# Work Order ID 110216

Item Name: Basket Hoop

DESIGN #	DRAWN BY CP	DART AEROSPACE LTD HAWKESBURY, ONTARIO, CANADA	
CHECKED #	APPROVED #	DRAWING NO. D3166	REV. A SHEET 1 OF 1
DATE 02.07.10		TITLE BASKET HOOP	SCALE NTS
A	02.07.10	NEW ISSUE	
A1	04.04.08	38+/-1 WAS 36.0

DRAWING NO. D3166	TITLE BASKET HOOP	REVA1	<b>DART AEROSPACE LTD ENGINEERING ORDER</b>		D.E.O. NO. D3166-A-2	SHEET NO. 1 OF 1	SCALE NTS
DRAWN AJS	CHECKED [Signature]	MFG. APPR. [Signature]	APPROVED [Signature]		DE APPR. [Signature]		
DATE 08.12.11	DATE 08.12.15	DATE 08/12/15	DATE 08/12/16		DATE 08.12.16

D3166-1 BASKET HOOP

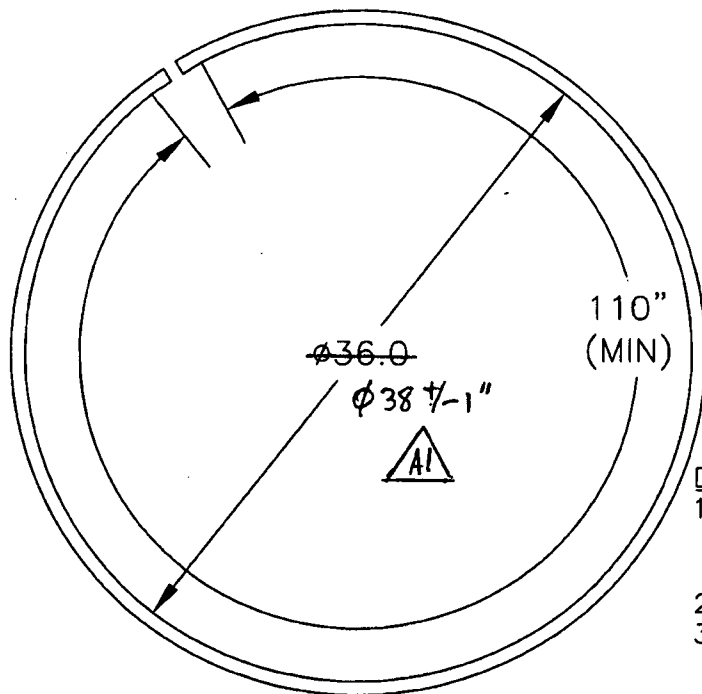
1) MODIFY MATERIAL NOTE FOR D3166-1 AS SHOWN:

WAS:

1) MATERIAL: AISI 304/316 SS SQUARE TUBING,  
0.75" x 0.75" x 0.063 WALL, 60.00" LONG  
(REF DART SPEC. M304TS0.750W.063)

2) MODIFY MATERIAL NOTE FOR D3166-3 AS SHOWN:

WAS:

1) MATERIAL: AISI 304/316 SS SQUARE TUBING,  
0.75" x 0.75" x 0.063 WALL, 120.00" LONG  
(REF DART SPEC. M304TS0.750W.063)

IS:

1) MATERIAL: AISI 304/316 SS, 3/4 X 3/4 X 0.065 WALL SQUARE TUBING,  
60.00" LONG  
REF. DART SPEC M304TS0.750W.065

IS:

1) MATERIAL: AISI 304/316 SS, 3/4 X 3/4 X 0.065 WALL SQUARE TUBING,  
120.00" LONG  
REF. DART SPEC M304TS0.750W.065
